RE: PLANNING REF 22/02168/F

Drawing 01 – Visibility Splays and Swept Path Analysis

Project
**MFG REDLAND SERVICE STATION
 HAMPTON ROAD, BRISTOL**

Drawing
**SWEPT PATH ANALYSIS
 AND VISIBILITY**

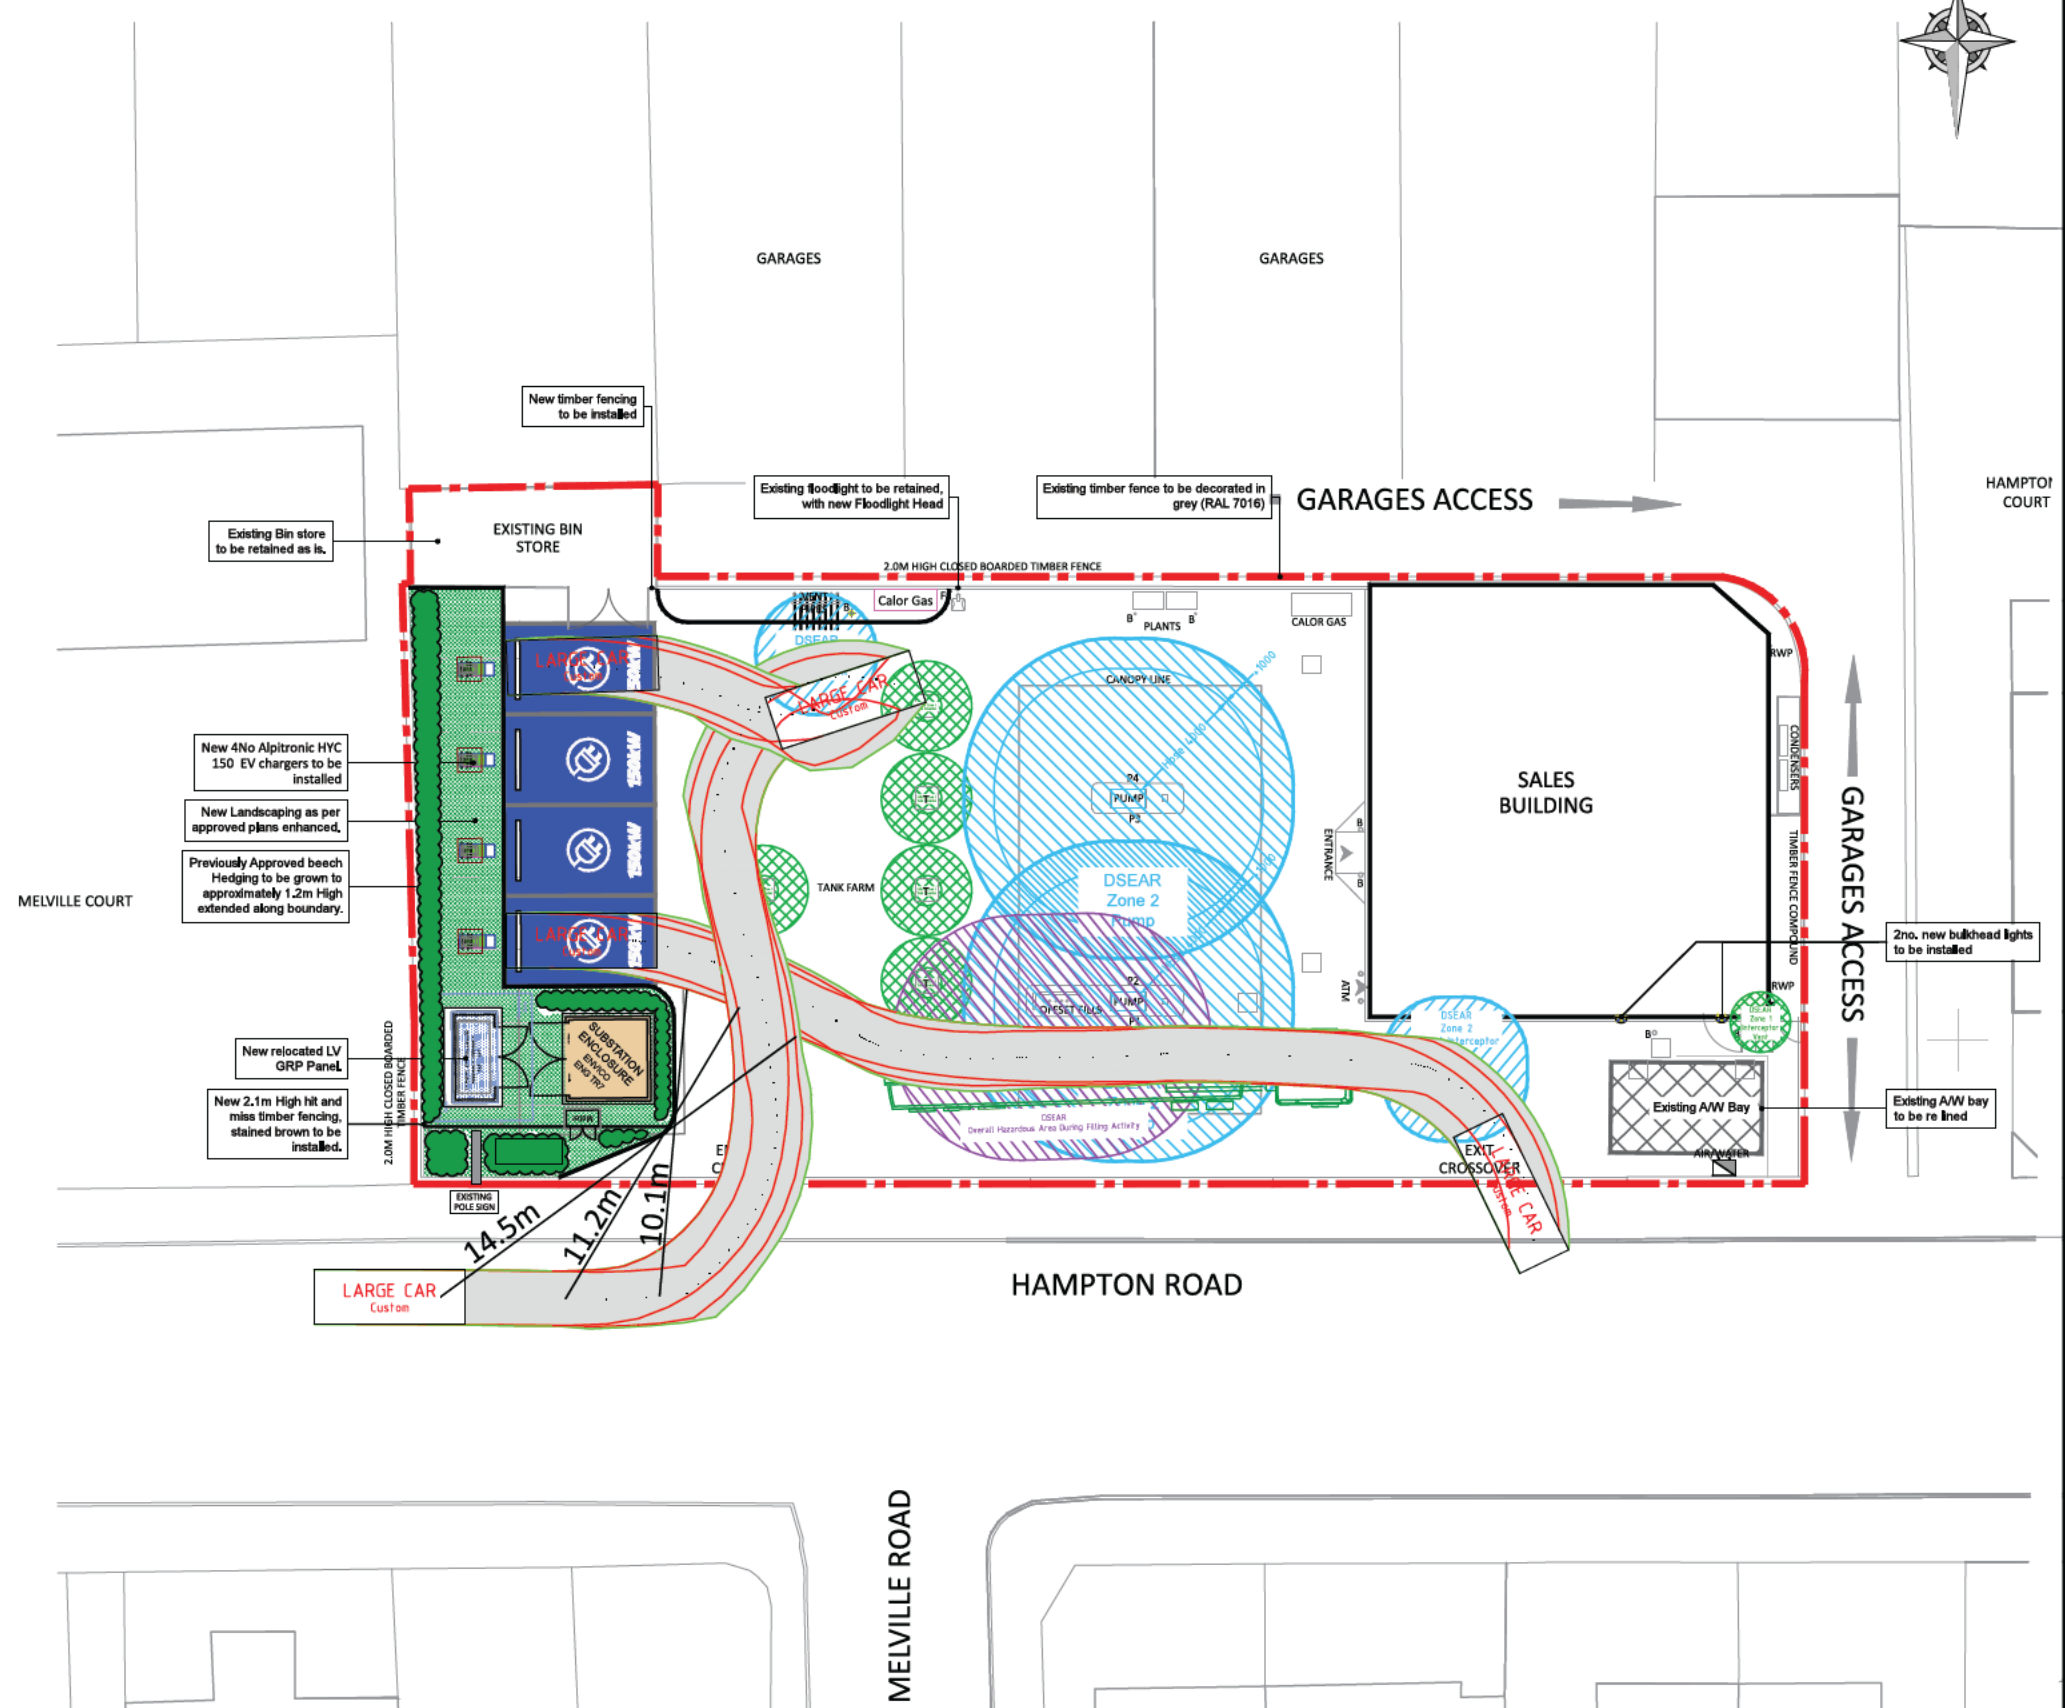
1. Visibility from Hampton Road to traffic emerging from the EV spaces; and
2. The absence of swept path diagrams showing how traffic would enter/leave the EV spaces.

It is the opinion of TDM that traffic entering the site would be at greater risk as a result of the visibility that would be available to traffic entering the site (presumably from the west only) to cars exiting the EV spaces. The Council has requested the applicant to demonstrate "adequate vehicular visibility splays" but without stating any standard or guidance for any such requirement. Typically, visibility standards only deal with traffic at junctions (visibility splays) or along the carriageway (forward visibility), both of which are based on a required Stopping Sight Distance (SSD) as calculated from the speed of traffic. The crossover in question is an ingress only and so no visibility splay

standard would apply. In terms of forward visibility, any vehicle turning in to the site would be doing so at an appropriately low speed (5-10mph). For traffic travelling at this speed, the Manual for Streets Table 7.1 advises an SSD of 11 metres. Notwithstanding any of the points made above, Drawing 01 enclosed has been produced to illustrate indicatively the intervisibility between vehicles exiting the EV bays and traffic turning into the site from the west. The drawing indicates that visibility splays of 10-14.5m are achievable, which is perfectly acceptable for such a low-speed situation.

The planning application was refused because no swept paths were provided to show how vehicles would negotiate the EV Bays. These swept paths have been undertaken using a large car and shown on the enclosed Drawing 01. The swept paths clearly demonstrate that the EV bays are easily accessible.
